Re: Turkey Point Units 3 and 4
Docket Nos. 50-250 and 50-251
Response to Request for Additional Information for the
Review of the Turkey Point Units 3 and 4
License Renewal Application

ATTACHMENT 1
RESPONSE TO REQUEST FOR ADDITIONAL INFORMATION
DATED FEBRUARY 2, 2001 FOR THE REVIEW OF THE
TURKEY POINT UNITS 3 AND 4,
LICENSE RENEWAL APPLICATION

SECTION 3.2 **REACTOR COOLANT SYSTEMS**

FIGURE 1. Effect of Fluence and Oxygen Level on the IASCC Susceptibility of 304 S.S. (Reference 1)

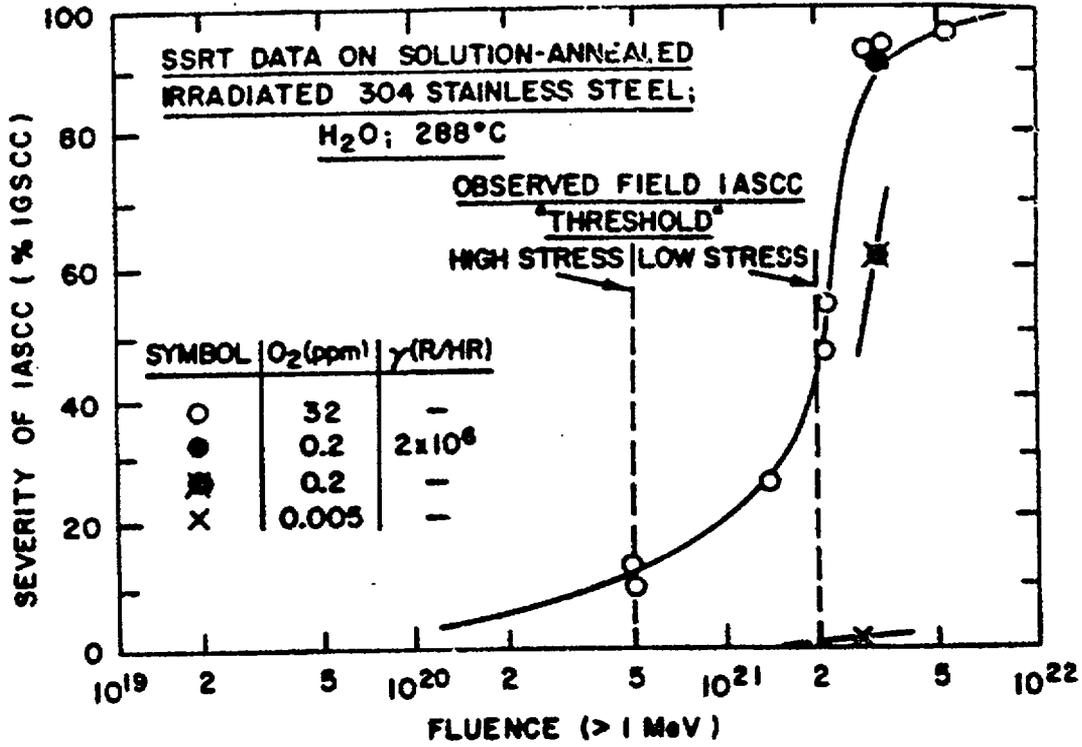
In Subsection 3.2.5.2.1, FPL indicates that; susceptibility has been observed at fluences as low as 1×10^{21} n/cm² in laboratory studies on Type 304 stainless steel in PWR environments, Type 316 stainless steel is less susceptible, and field information suggests that greater exposures are required for the development of susceptibility. The staff requests that FPL identify the field information that suggests that greater exposures are required for the development of susceptibility.

Figure 1 (Reference 1), shows the threshold type behavior in boiling water reactor (BWR) type environments with field data for observed cracking being at a somewhat higher threshold than laboratory data. The figure also shows that when the oxygen level is reduced to very low levels, closer to PWR conditions, the threshold for the laboratory observation of IASCC moves to greater than 10^{21} n/cm².

FIGURE 4. Fracture Toughness Behavior as a Function of Neutron Dose (Reference 10)

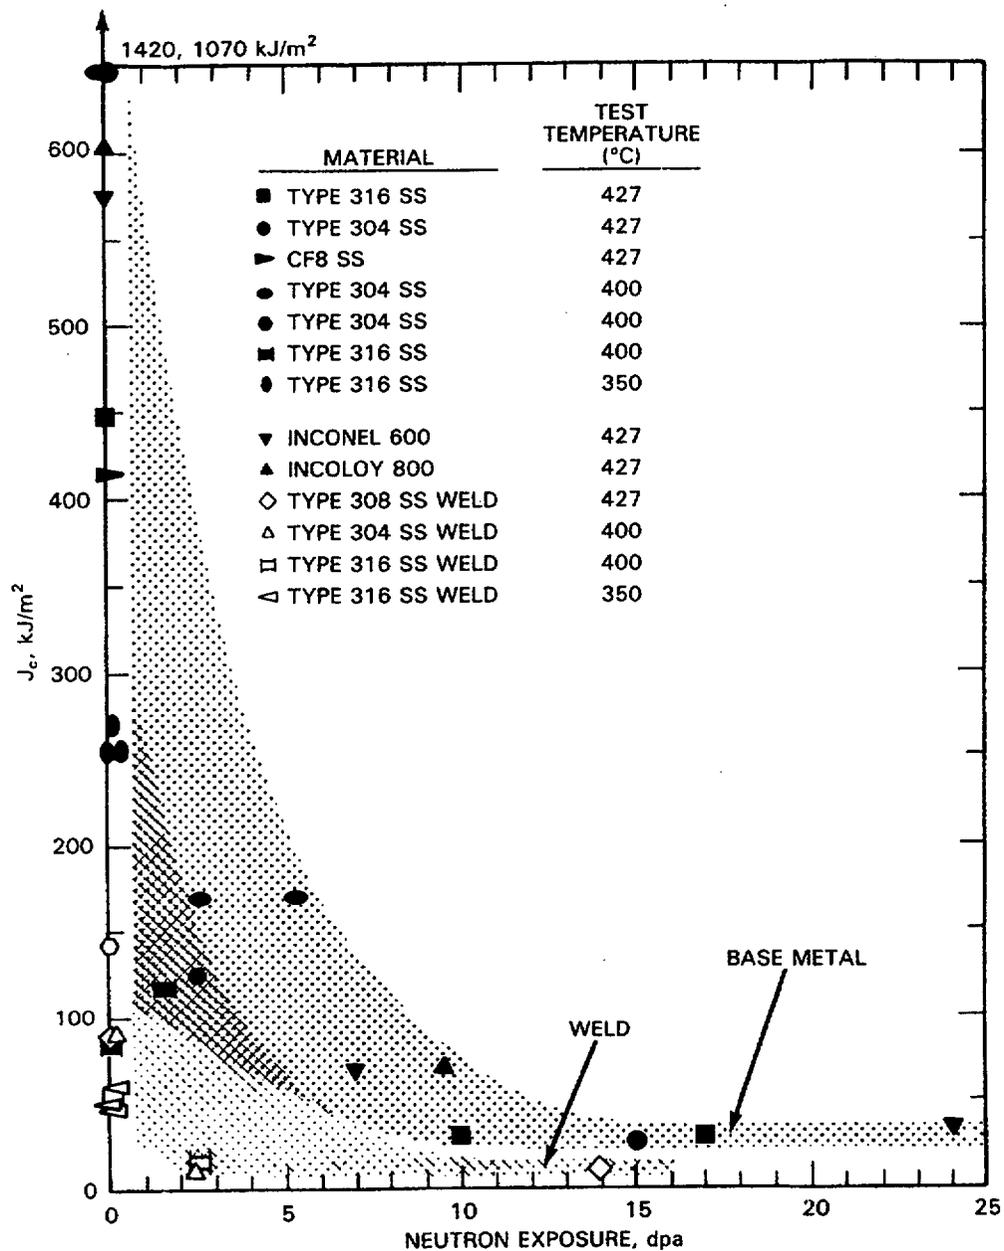
The application uses 1×10^{21} n/cm² (E > 0.1 MeV) as a fluence threshold for neutron embrittlement of stainless steel used to fabricate internal components. Provide data to support this position, or revise the application to expand the list of potentially susceptible components to include those at lower fluences.

There appears to be a similar reduction in toughness at fluences in the region of 10^{21} n/cm² for cast austenitic stainless steels, such as CF-8 and CF-8M, and for welds such as 308 and 309. The data for many welds irradiated at intermediate temperatures (370°C to 430°C), even those with high molybdenum, show that "exposures up to 1 dpa have no significant effect on fracture resistance (Reference 7)." The literature data on castings is limited (Reference 10). That which is available indicates that the fracture toughness of an SA351 CF8 casting with 15% delta ferrite behaves in a similar manner to a 308 stainless steel weldment with 7% delta ferrite when irradiated (Reference 10). The data is less than that observed for the wrought material (see Table 1) suggesting that the saturation value is less, probably due to the ferrite in the structure. The austenitic phase will continue to fail in a ductile manner, as shown previously. The threshold before signs of embrittlement are observed appears to be similar to that for the wrought austenitic materials, see Figure 4.
